RE: Block F Rezoning/OCP Amendment Application Response to UEL Letter dated Feb 6, 2014

Re: Block F Development Approval Response from UEL dated February 6, 2014

To:	Steve Butt	From:	Steve Jeffares
Cc:	Gordon Easton	Date:	March 5, 2014
Project #:	Block F, 545-40	File:	12-125-03
Re:	Musqueam Block F – Development Approval Information

DATE: March 26, 2014
PROJECT: 4912-01
NO:
PROJECT: Block F Development, University Endowment Lands
SUBJECT: Response to UEL Staff Comments Regarding the Transportation Assessment Report

SHEET TITLE:
CONCEPTUAL
SERVICING PLAN
SANITARY OPTION A
(GRAVITY)

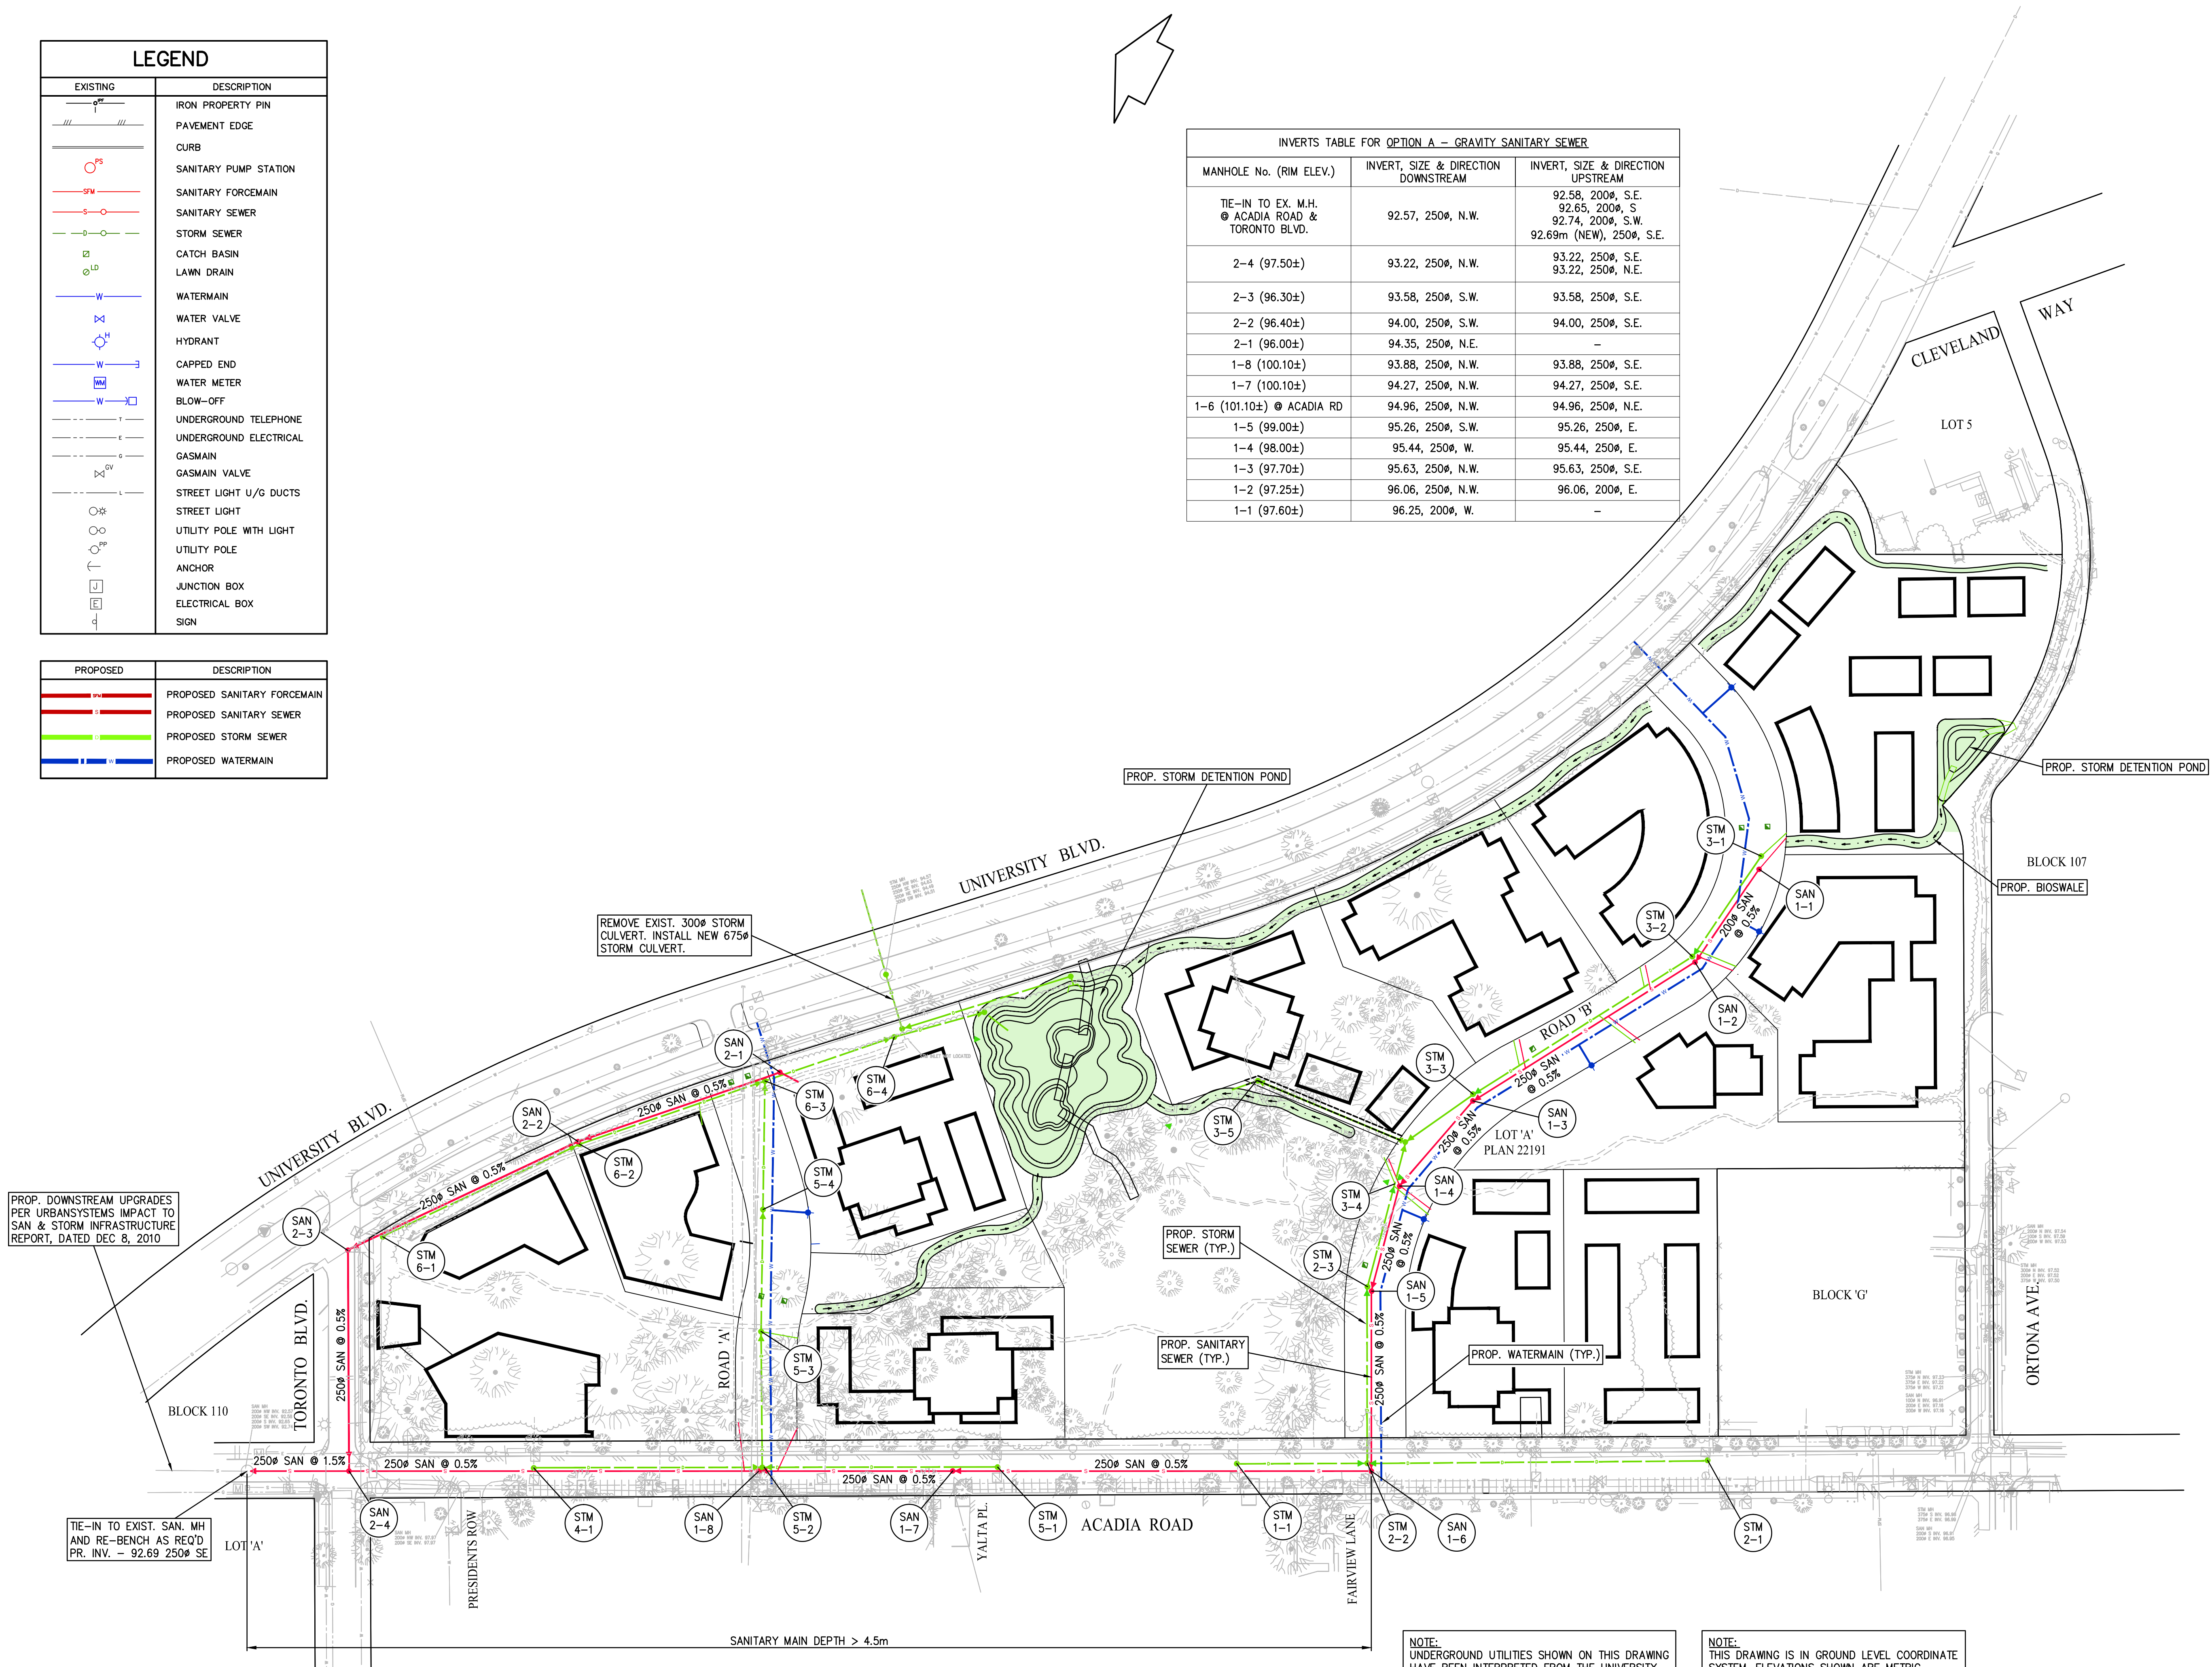
- a.) Elevations: Show elevations of the utilities and the ground ("rim elevations") at all manholes, tees and tie-ins with existing infrastructure.*
- b.) Sewers: Show slopes of all proposed gravity sewers.*
- c.) Gravity Sanitary Sewer: Show a gravity sanitary sewer system or demonstrate why a gravity system is not feasible. If a gravity sanitary sewer system is not feasible, please show a system that does not require UEL to take ownership and maintenance of a sanitary pump station (e.g a low pressure system or strata maintained pump station).*

Drawing CSP-1A shows the option of installing a gravity sanitary sewer system for the entire development site. The tie-in location is just north of the intersection of Acadia Road and Toronto Blvd. This option is able to maintain a minimum 0.5% slope on all sections of the main, however, for approximately 280 meters of sewer along Acadia Road, the sewer will be greater than 6.5 meters deep and will require more difficult construction, installation and maintenance procedures.

CONCEPTUAL
STORMWATER
MANAGEMENT
PLAN

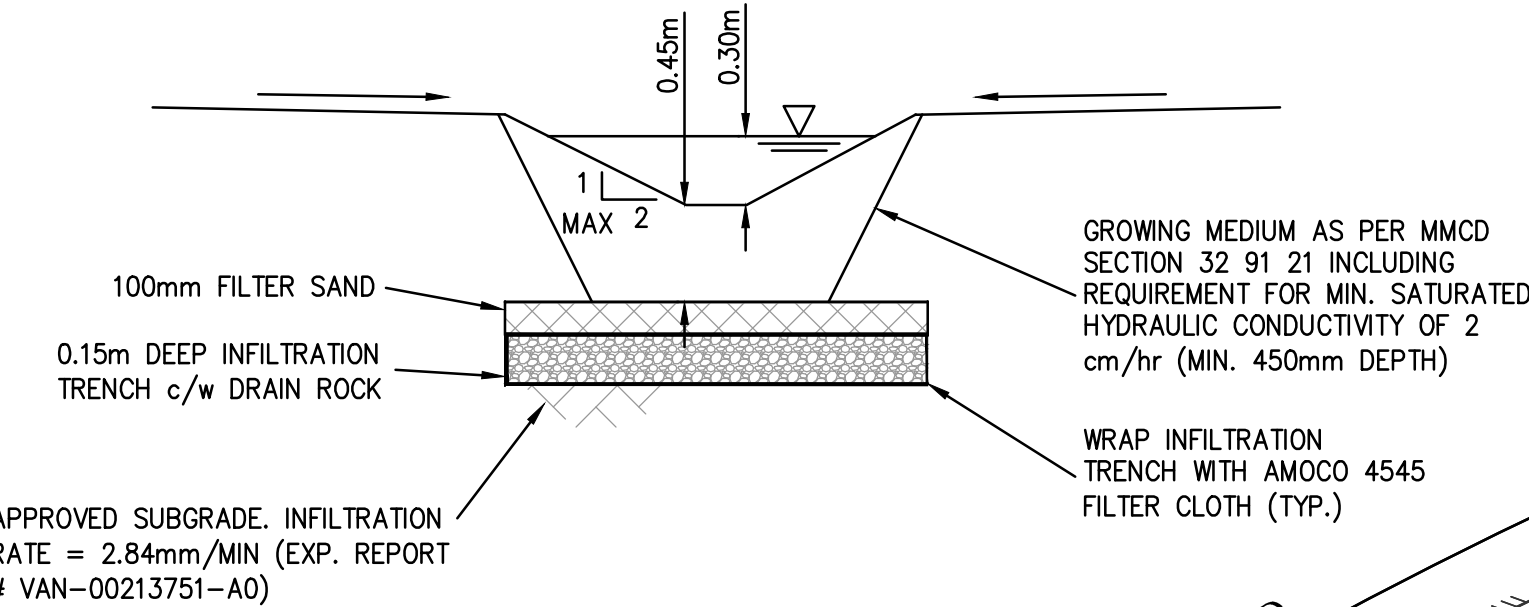
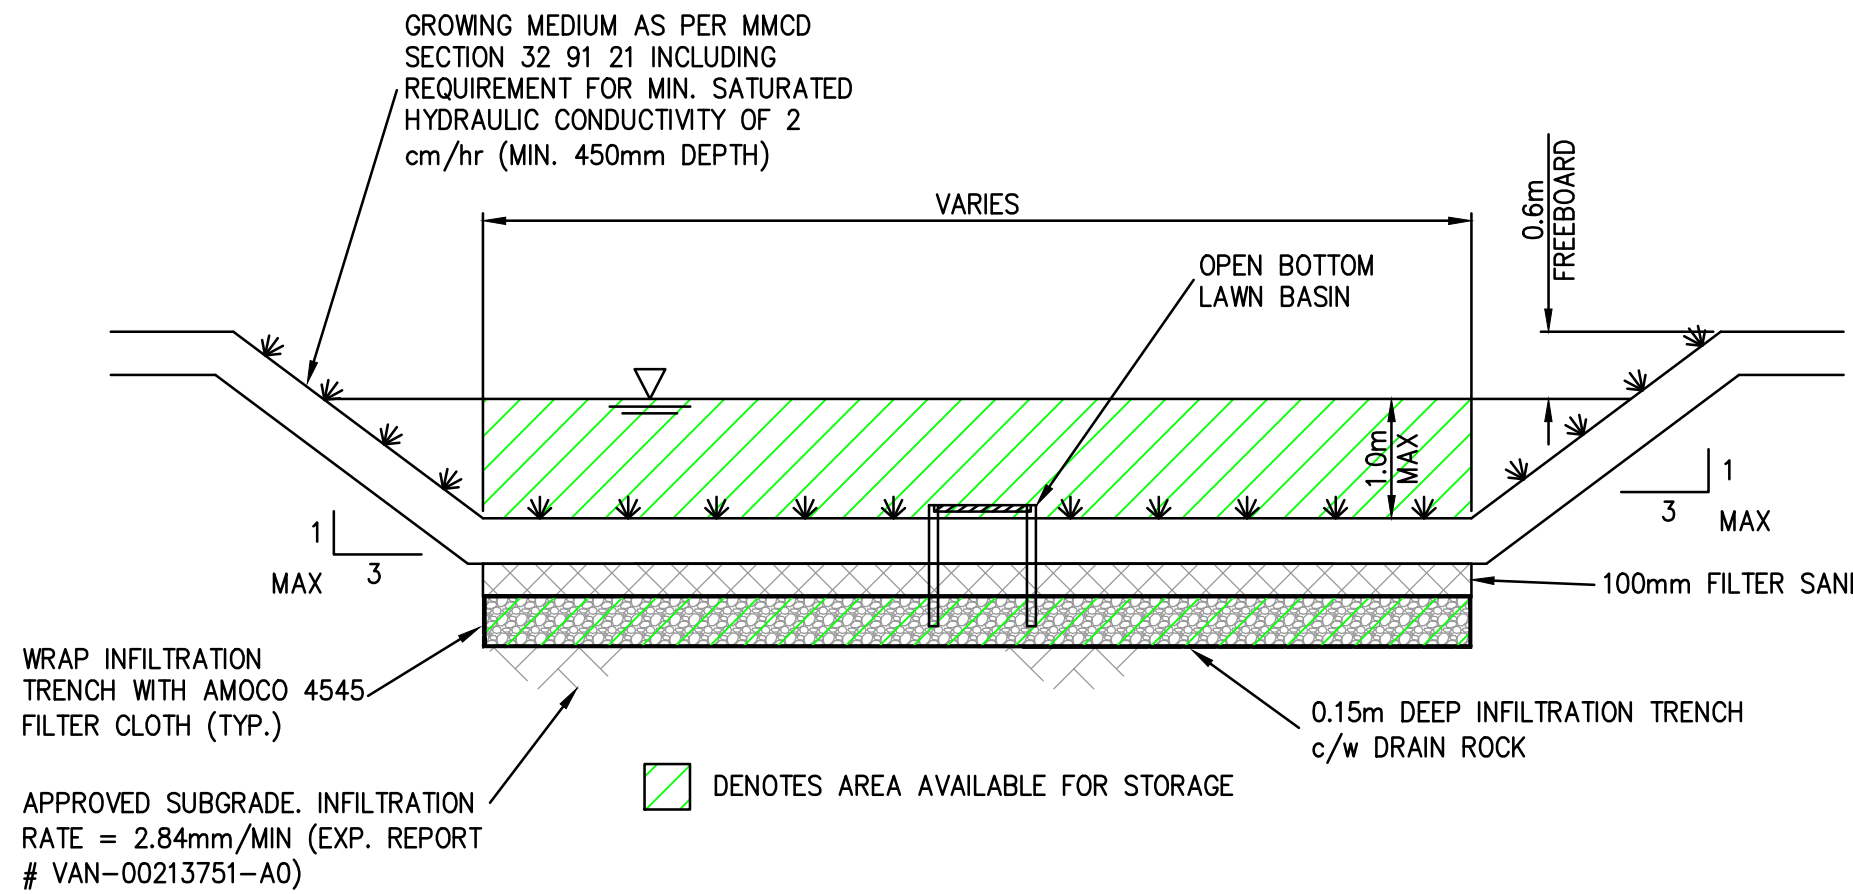
- a.) Wetland Storage Volume: Show the proposed depth, profile and cross sectional area of the swales and wetland used to calculate the available storage volume.*

- b.) Wetland Design: Pond inlets should not be adjacent to pond outlets as the water will "short-circuit" and not have sufficient retention time for treatment. Please show the water circulation pattern, and demonstrate that the water will not short-circuit.*

- c.) Wetland Bed: Please confirm whether the proposed wetland is a "typical" wetland that retains water or whether it is would have a "porous" bottom for infiltrating stormwater.*

- d.) Surface Area for Stormwater: Show the available surface area and assumed soil infiltration rate assumed for infiltrating stormwater. Please provide calculations showing the amount of stormwater to be infiltrated through the bioswales and retention pond.*

- e.) Stormwater Treatment: The submission refers to stormwater being "treated" before reaching the wetland, but does not provide details as to how this will be achieved. Specifically the environmental report says that "there will be no direct runoff of dirty stormwater from future site development to the constructed wetland." Please provide details as to the level of stormwater treatment and how it will be achieved.*

The stormwater management plan has been revised to include details requested from the letter. Cross sectional details of the pond and bioswales showing proposed depth and other details have been added to the SWMP-1 drawing. The outlet of the detention pond has been shifted south along University Boulevard, approximately 60m away from the inlet to allow water to flow through the detention pond prior to discharging to the culvert under University Boulevard. The detention pond is designed to allow infiltration of the captured runoff into the subsurface layers for groundwater recharge. In addition, open bottom lawn basins are proposed to further promote infiltration by directing the water directly through the soil layers to the more permeable subsurface layers. Detailed calculations and the preliminary geotechnical report are appended to this memo for reference.

The proposed bioswale and detention pond will provide some treatment and allow particles to settle prior to discharging to the offsite storm system. Furthermore, treatment manholes are proposed on the two pond inlets to the detention pond for further treatment. Therefore, the future site development will not affect the water quality downstream of the development.
